NZ 179/05 AUSTRALIA – Coral Sea – Calder Banks – Depths.

Aus Notice 454/05
 NI 160/2005

Chart NZ 14602 (INT 602) [138/05]

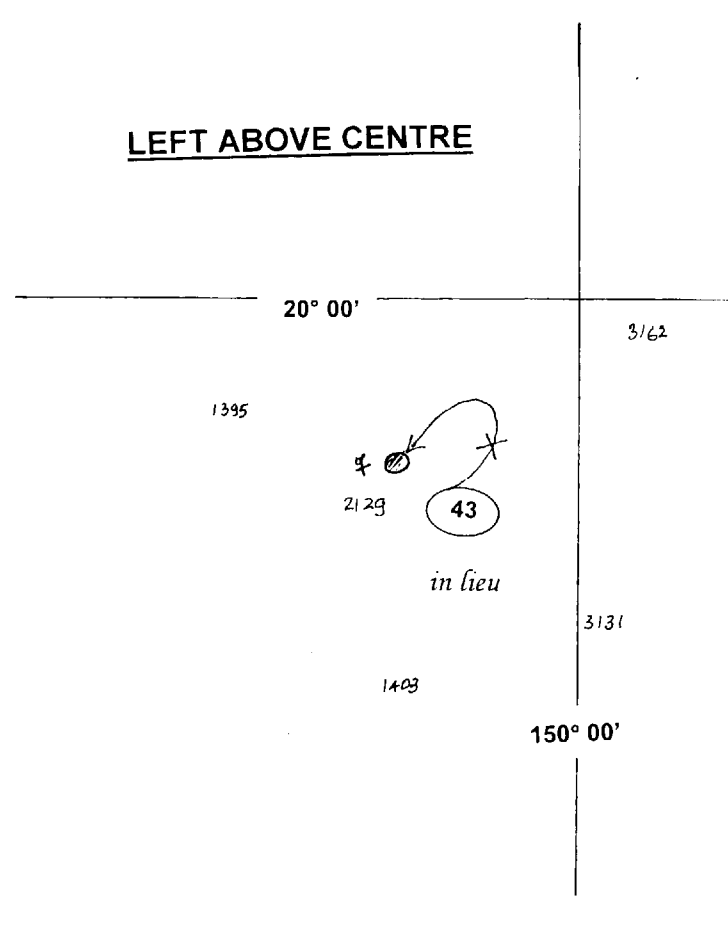
Substitute depth 43, for depth 44m 20° 41S., 154° 12'.0E.

Chart NZ 14604 (INT 604) [81/05]

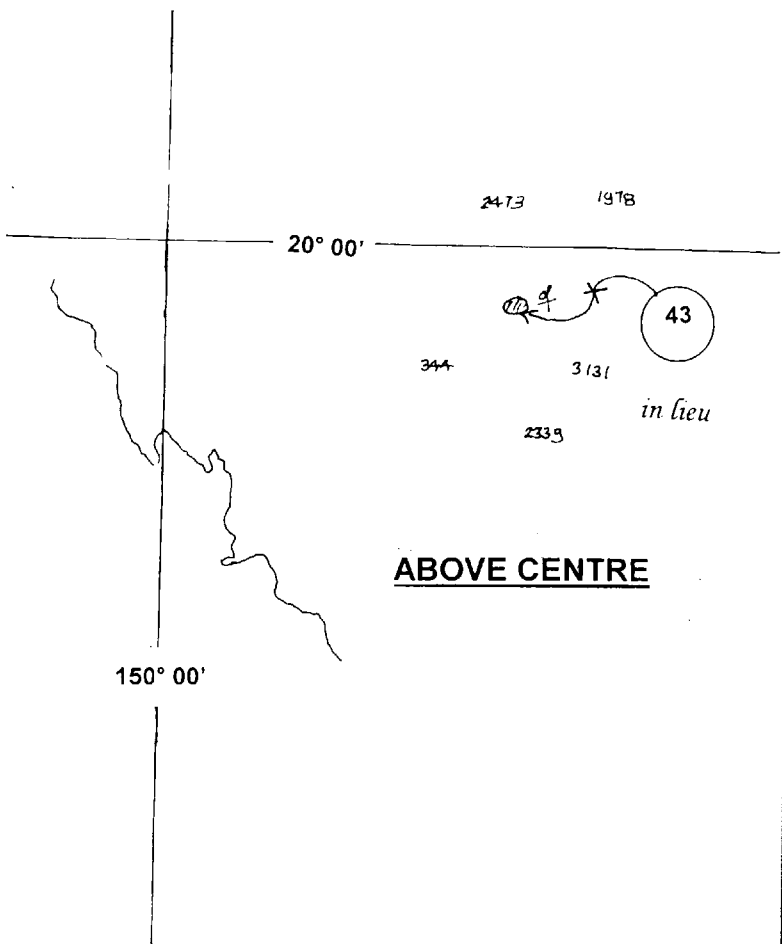
Insert depth 43, and extend contour N. to enclose (a) 20° 40'.9S., 154° 12'.4E.

Delete depth 44m close S. of (a)
